CHAPTER 16: TRAFFIC

ONE DIRECTION LARGE ARROW

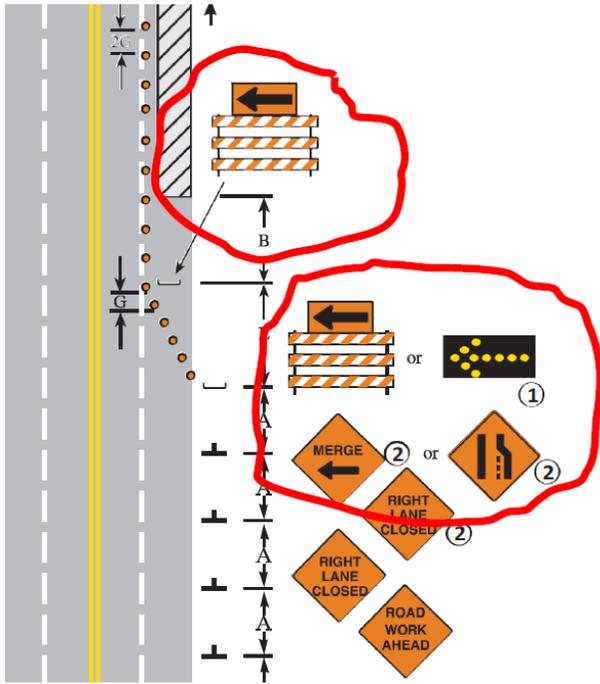
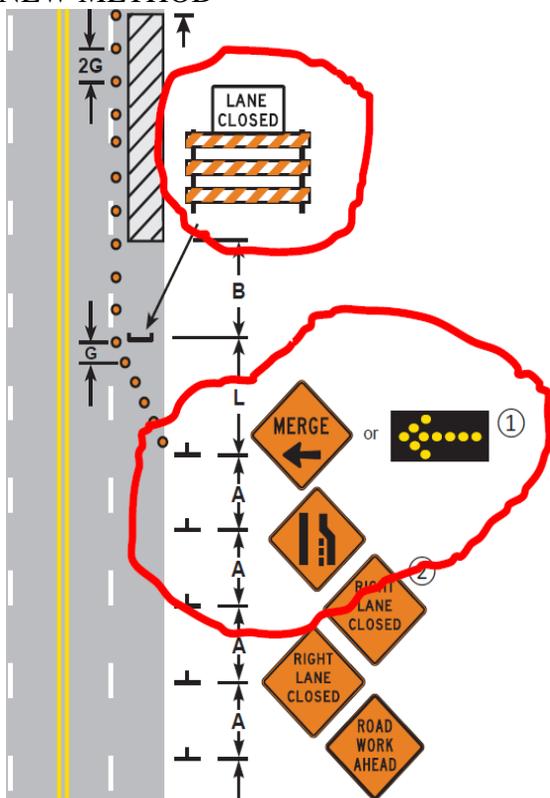
However, there was no language in TTC (Temporary Traffic Control) chapter of the MN MUTCD that allowed this use. The One-Direction Large Arrow is governed by language in Warning Signs Chapter 2C (2C.12) that limits its use to delineating a change in horizontal alignment for curves. Language was drafted for consideration by the Minnesota Committee on Uniform Traffic Control Devices, but it was found to not be in compliance with the Federal MUTCD.

Per a recent clarification from the FHWA, it cannot be used for merging tapers, though it will still be used for shifting tapers. **Therefore, for all projects submitted for the January 26, 2018 letting or later must following the new layout as described below.**

Due to this clarification, the Field Manual Committee has developed new layout, instead of the One Direction Large Arrow on the Type III barricade at the end of the taper, a LANE CLOSED (black on White) sign will be used (required when speed limit is 45 mph or greater). If the Flashing Arrow Board is not used (it is required when speed limit is 45 mph or greater), a MERGE with Arrow sign will be placed at the beginning of the taper.
